ITEM 9. SECTION 96 MODIFICATION APPLICATION: 57 ASHMORE STREET AND 165-175 MITCHELL ROAD ERSKINEVILLE**FILE NO:** D/2015/966/A**DEVELOPMENT APPLICATION NO:** D/2015/966/A**SUMMARY****Date of Submission:** 25 May 2016

Proposal Summary: This Section 96(2) application seeks consent to modify the Concept Approval for a mixed use precinct including residential, commercial and recreation uses, including building envelopes for nine (9) development blocks ranging in height between two (2) and eight (8) storeys and concept design for public domain works including new streets, a 7,446m² park, and new trunk drainage.

The proposed amendments principally involve altering the approved building envelopes to accommodate the detailed design DA for Blocks B and C (D/2017/681) resulting from a design excellence competition. Amendments to specific conditions are also proposed.

Figure 34: Selected Concept Approval modelled views

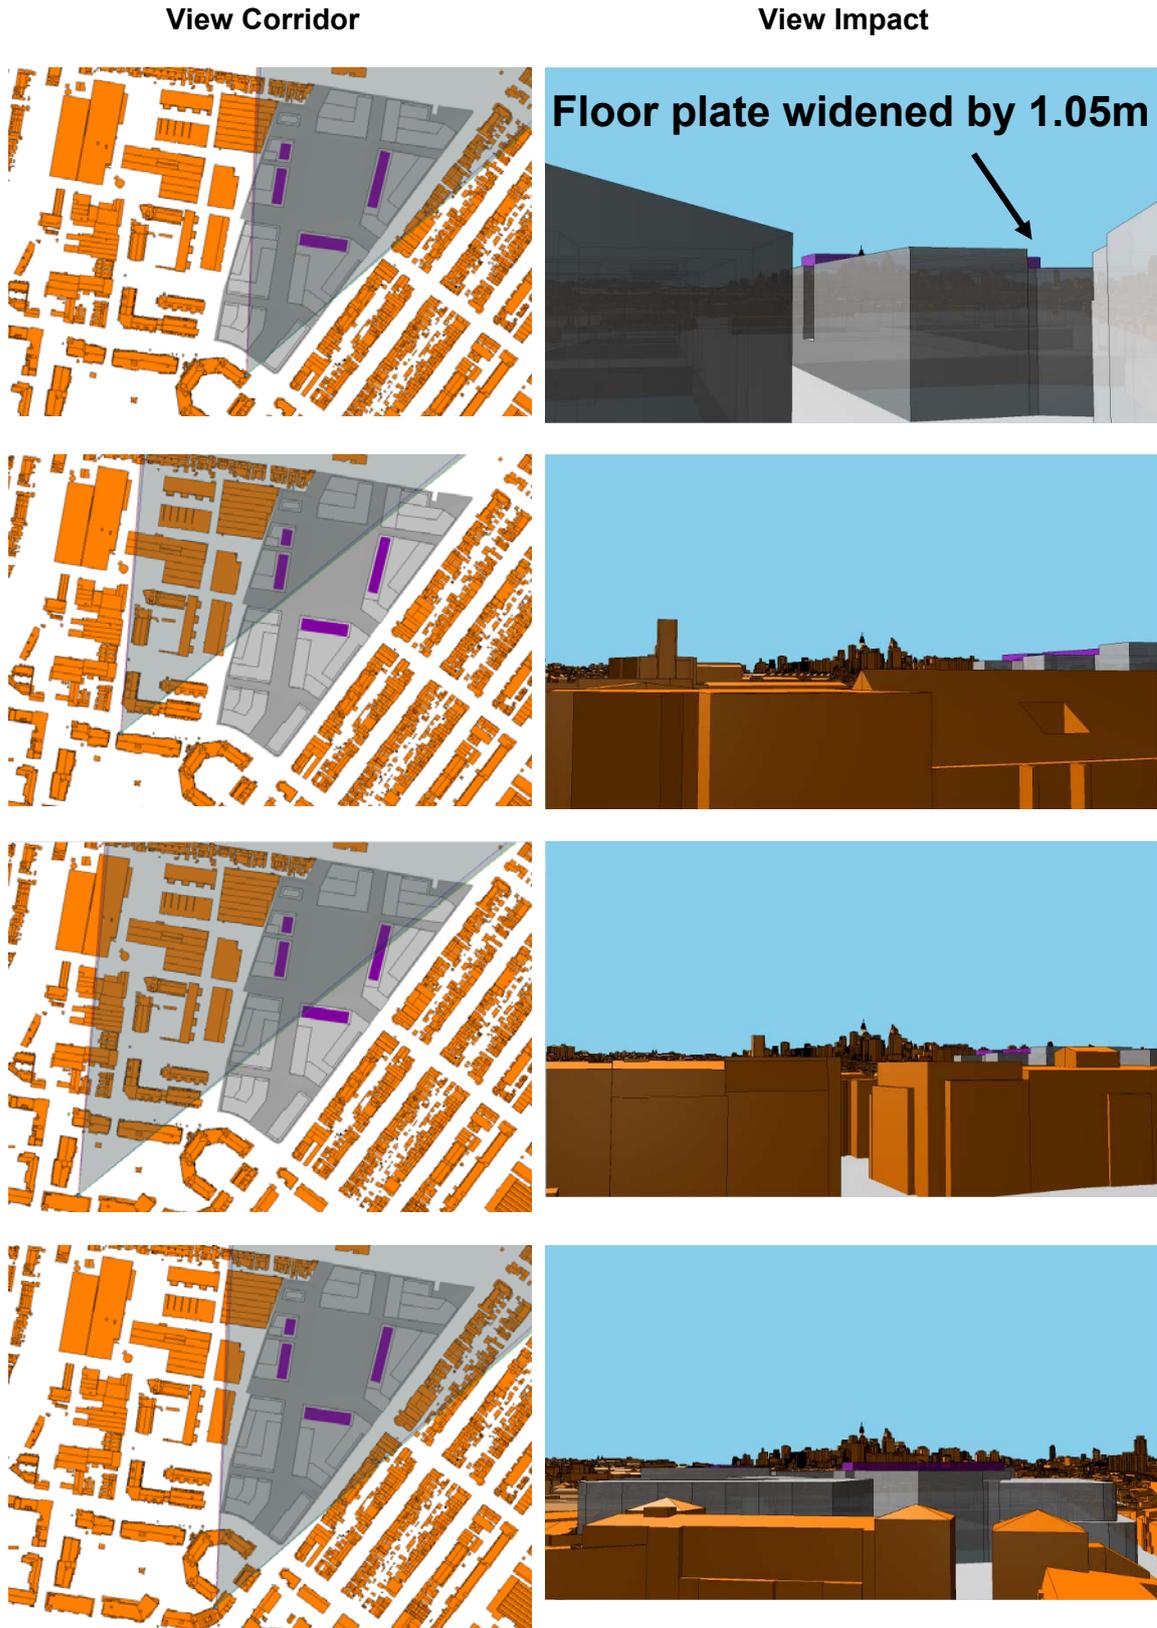
In order to determine if the increased width of Level 8 of Building C01 would have an impact, the modelled views generated by Council officers when assessing the original Concept Development Application have been re-examined. Selected modelled views are reproduced in Figure 34 below, annotated with the location where the Level 8 floor plate, widened by 1.05m may be visible. The images demonstrate that there will be no discernable impact upon private views arising from the proposed widening of this floor plate.

Figure 35: Extract from solar access study, annotated to highlight the 'pop-out' windows which assist in achieving solar access for a period of two hours at midwinter

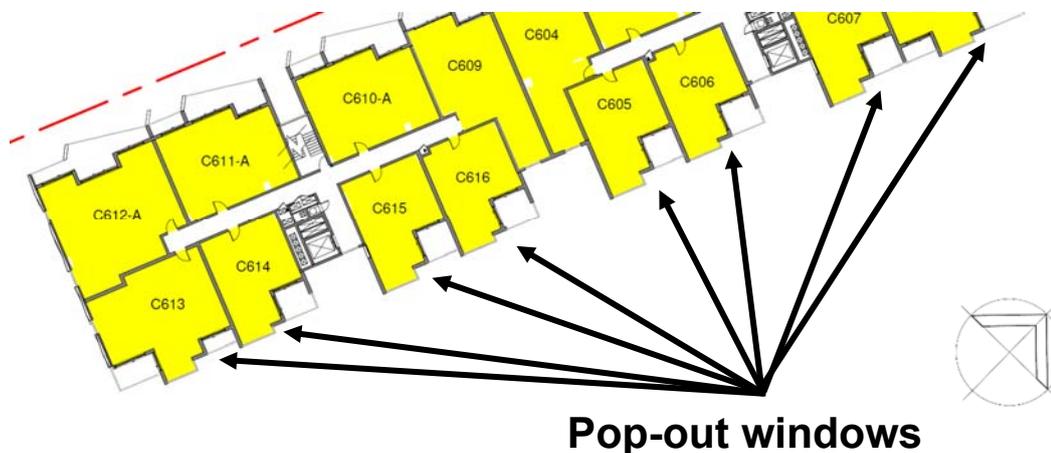
- (vi) The non-compliance on the eastern face of Building C01 (annotated C in Figure 32) facilitates improved solar access to apartments by providing a 'pop-out' window with glazing orientated to the north, as illustrated in Figure 35 below. If the facade was flattened in order to contain the building entirely within the 27m height plane, the affected apartments would no longer achieve two hours solar access at mid-winter, and overall solar access would be non-compliant with the minimum requirements of the ADG. While the proposed variance is technically large (62.1%), in reality it is only a very small part of the building that is protruding into the adjoining height plane. The proposed non-compliance is considered to result in an improved outcome for the site, and therefore a request to flatten the facade to contain it within the 27m height plane would be unreasonable.

Figure 36: Extract from the tree survey, demonstrating that the building envelope is able to move closer to the trees without undue impacts

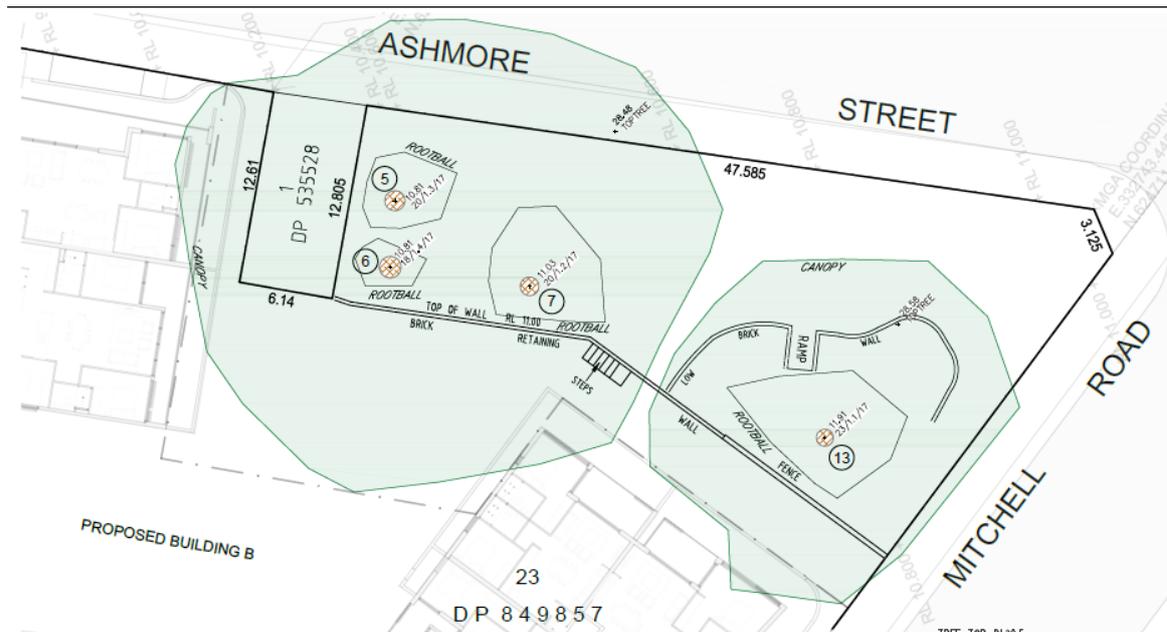
42. The proposed modifications to the building envelopes include extending building B03 towards the north-east, increasing the extent of the Mitchell Road frontage from 30m to 35.3m, and bringing the building closer to the retained Hills Weeping Fig Trees.
43. A survey of the Hills Weeping Fig Trees and an arborists report has been submitted with the concurrent detailed design DA for Blocks B and C (D/2017/681), which demonstrates that moving the building envelope in this manner will not have an unacceptable impact upon the trees. An extract of the survey is provided at Figure 36 below.

44. In light of the above, the proposed modification is acceptable in terms of its impact upon the retained trees.

Figure 37: Block I as approved

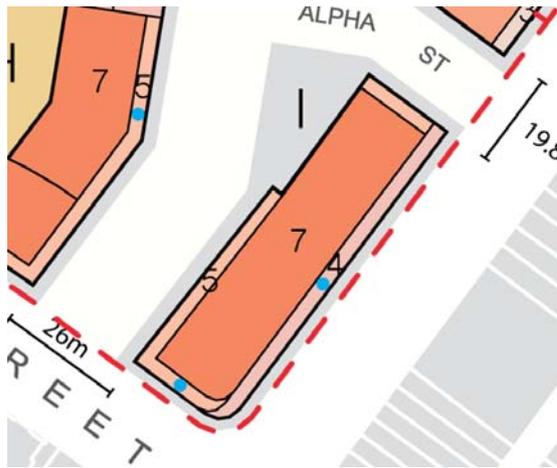
48. The amended drawings submitted in October 2017 include an undisclosed change to the Block I building envelope. Specifically, the inclusion of a podium level with an area of approximately 276m² in the north western corner of the block. The podium is situated at the corner of the future Kooka Walk and Alpha Street. Figures 37 and 38 below provide a comparison of the Block I building envelope, as approved, and as proposed to be modified.

49. The documentation submitted with the application has not provided any details with regard to the proposed change, nor has any justification for the change been provided.
50. It is noted that the maximum FSR development standard for the overall site is 1.75:1. Assuming a residential floor plate efficiency of 80%, the newly proposed podium level is capable of accommodating up to 220.8m² of additional GFA. This would increase the approved FSR from 1.75:1 (compliant), to 1.753:1 (non-compliant).
51. In light of the above, the proposed amendment to Block I is not supported. An additional condition 1A 'Design Modifications' is recommended, requiring the Block I podium to be deleted from the plans prior to the preparation of any brief involving a competitive design process for Block E.

Figure 39: Extract from the Concept Approval modelled views, illustrating the impact of the Stage 1 Concept approval from apartments in Sydney Park Village fronting Coulson Street

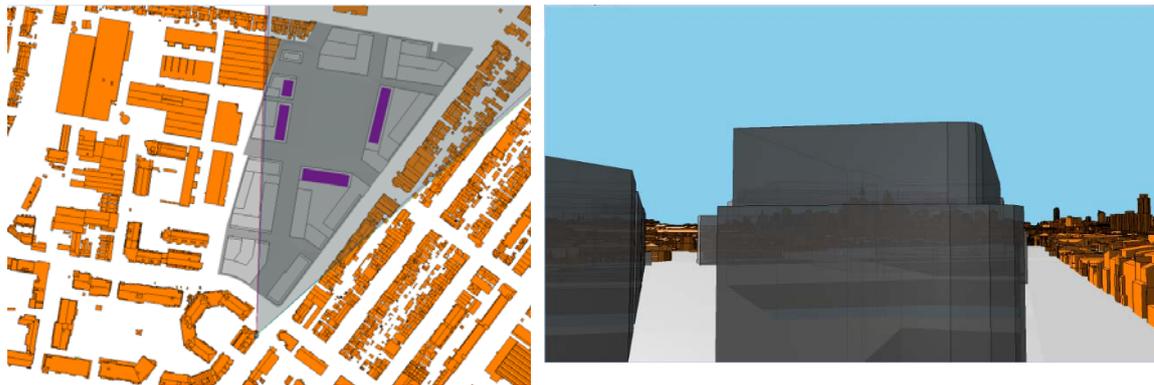
The Concept Approval assessment report clearly set out that existing views from this location to the City could not be preserved if buildings were constructed to the maximum height permitted under the SLEP 2012. Figure 39 below is an extract from the modelled views contained within the Concept Approval report. As illustrated redevelopment of the site will result in view loss from apartments in this location.

Importantly, the modelled views demonstrate that impact to apartments on low floors within Sydney Park Village are impacted by Blocks H and I fronting Coulson Street, and not Blocks B and C, which contain the building envelopes proposed to be amended under this Section 96 application. Accordingly, the building envelopes for Blocks B and C, as proposed to be modified, will have no impact upon private views from the submitter's apartment.
